PHAP18-00045

Date: December 3, 2018
Application Type: Certificate of Appropriateness
Property Owner: Maria Ofelia Ramos
Representative: Jesus Ramos
Legal Description: Lot 75 Government Hill 7 & 8 (7000 Sq. Ft.), City of El Paso, El Paso County, Texas
Historic District: Austin Terrace
Location: 4315 Trowbridge Drive
Representative District: #2
Existing Zoning: R-4/H (Residential/Historic)
Year Built: 1917
Historic Status: Contributing
Request: Certificate of Appropriateness for repaving the front yard, side yard, and driveway with masonry
Application Filed: 11/29/2018
45 Day Expiration: 1/13/2019

Certificate of Appropriateness for repaving the front yard, side yard, and driveway with masonry

PROPOSED PLAN

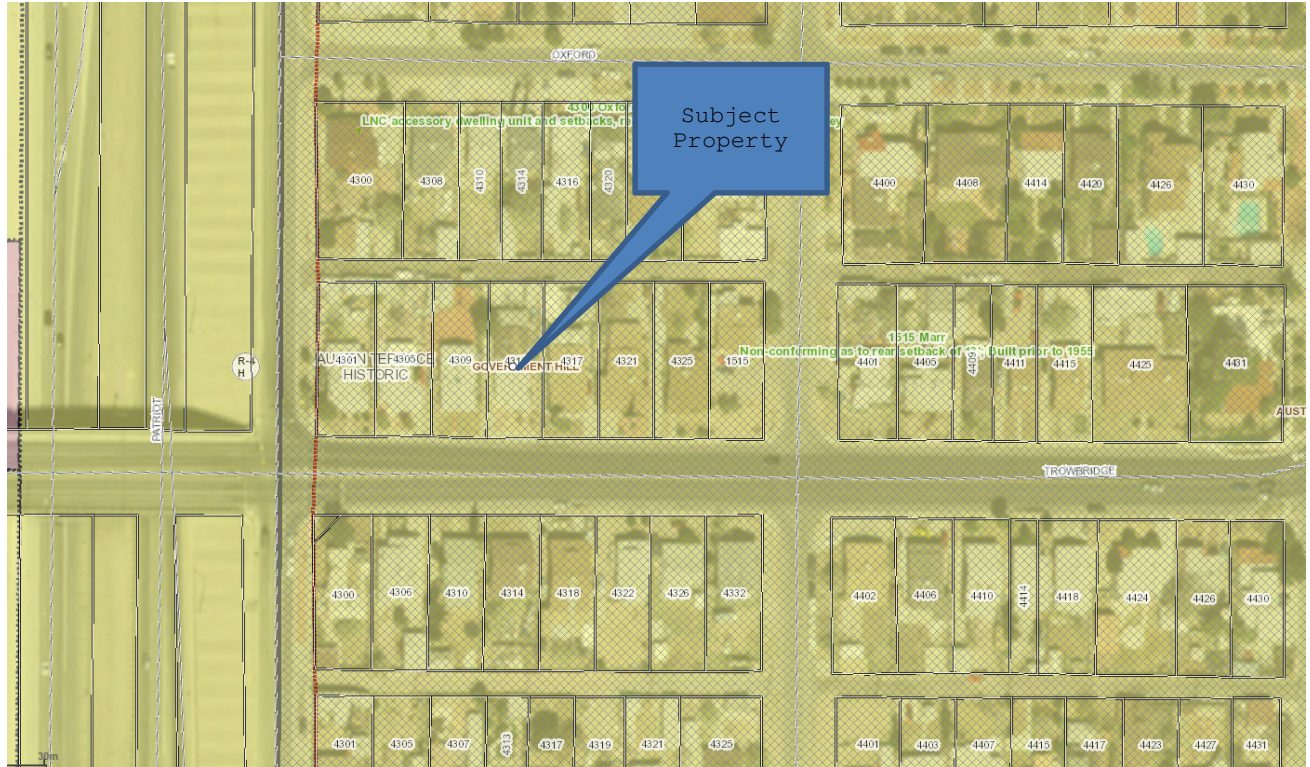
The Historic Preservation Office recommends APPROVAL WITH MODIFICATIONS of the proposed scope of work based on the following recommendations:

- *When repair or replacement is required the existing structure (garage or driveway) should be replaced in kind. Many of the driveways are the type which has two paved driving surfaces and a center strip of grass or other material. It is not appropriate to fill this area with concrete. However, bricks, stones and landscaping are usually considered acceptable.*

- *When deteriorated, repair with materials that match or are compatible to the original.*
- *Select appropriate materials for new driveways including concrete tracks (narrow strips) and brick. Conceal edging materials used for gravel driveways. Keep new driveway aprons and curb cuts to the minimum width possible.*

- *Grass and sod may be removed from front yards, side yards on a corner provided not more than 50% of the area is covered with gravel or other masonry. Grass and sod may be removed from parkways provided not more than 50% of the area is covered with gravel or other masonry that is made of impervious materials (brick pavers, gravel, and masonry pavers). The remaining 50% must be covered with trees and living plants that provide ground cover.*

The modifications are that the driveway be replaced with two concrete strips, that the center be filled with brick or stamped concrete to resemble brick, and that the front yard be paved with no more than 50% masonry and the other 50% be living plant cover.
